KING EDWARD MEMORIAL PARK FORESHORE APPLICATION STATEMENT

**To support a proposed non-material amendment
to the Thames Water Utilities Limited (Thames
Tideway Tunnel) Order 2014 (as amended)**

Name	Data
Document ref:	2530-TDWAY-TTTUN-990-ZZ-RG-704427
Legacy document ID:	
Document type:	Report
WBS Code:	n/a
Owner:	Roger Bailey
Author:	Liz Wood-Griffiths
Keywords:

Sketch 1 - Illustrative Comparison of KEMPF Online and Proposed Offline Layout

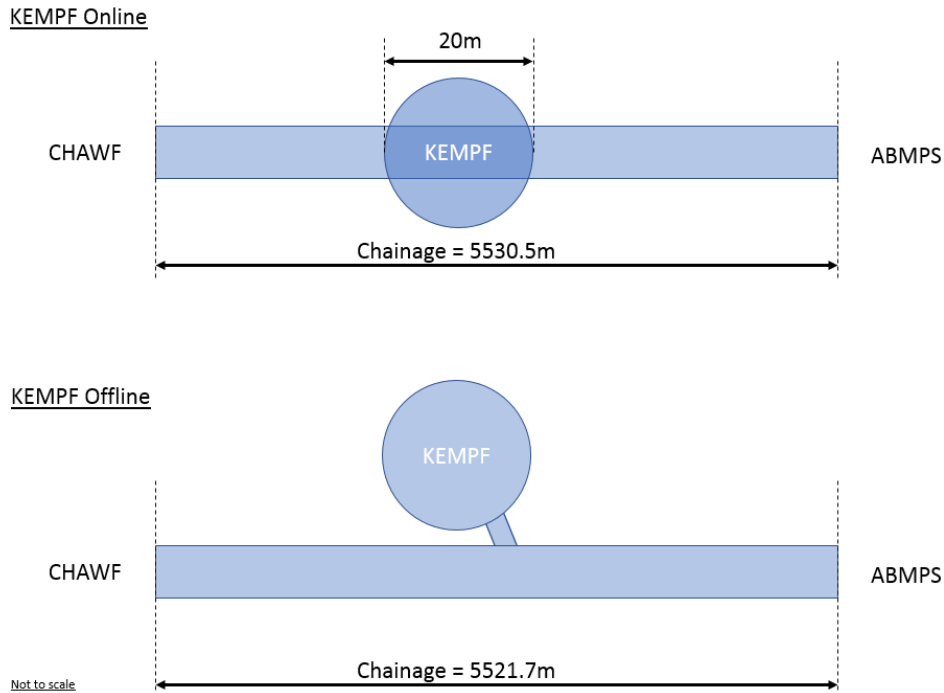
- 2.3.1 The amended scheme would see the main tunnel (east) realigned so that it passes to the south of the CSO drop shaft, and a short connection tunnel would be constructed to connect the CSO drop shaft and the main tunnel (east). The amendments are illustrated on drawing 5600-CVBJV-KEMPF-570-CT-DR-550001.

- 2.3.2 For structural reasons a minimum clearance of 3.8 metres is required between the outer face of the CSO drop shaft and the main tunnel (east). To achieve this clearance, the curvature of the main tunnel (east) would need to be realigned along a length of approximately 717m as shown on drawing 5600-CVBJV-KEMPF-570-CT-DR-550001. This would result in a slight decrease in the overall length of the main tunnel between Chambers Wharf and Abbey Mills pumping station of approximately 9 metres. The construction method for the main tunnel would remain unchanged.

- 2.3.3 Although the change proposed would reduce the overall chainage of the main tunnel by approximately 9 metres the overall storage capacity of the main tunnel will increase slightly because the tunnel will no longer pass through the CSO drop shaft. The authorised development provides for an online shaft where the main tunnel passes through the 20m diameter CSO drop shaft at KEMPF. In the online configuration the tunnel chainage through the shaft forms part of the drop shaft and hence is part of the drop shaft storage volume (see 'KEMPF online' in sketch 1). If the tunnel was taken offline and the chainage between the shafts at Chambers Wharf and Abbey Mills remained the same, an equivalent of around 20 metres of additional tunnel storage would be provided as a result of the tunnel and drop shaft being separate structures. The proposed change will take the main tunnel offline and reduce the main tunnel chainage between the shafts at Chambers Wharf and Abbey Mills by approximately 9 metres. This is illustrated in Sketch 1 below. This will have the effect of increasing the total storage volume between the shafts at Chambers Wharf and Abbey Mills by the equivalent of

approximately 11 metres of main tunnel. The CSO shaft storage is unchanged. Additional capacity is also provided by the connection tunnel.
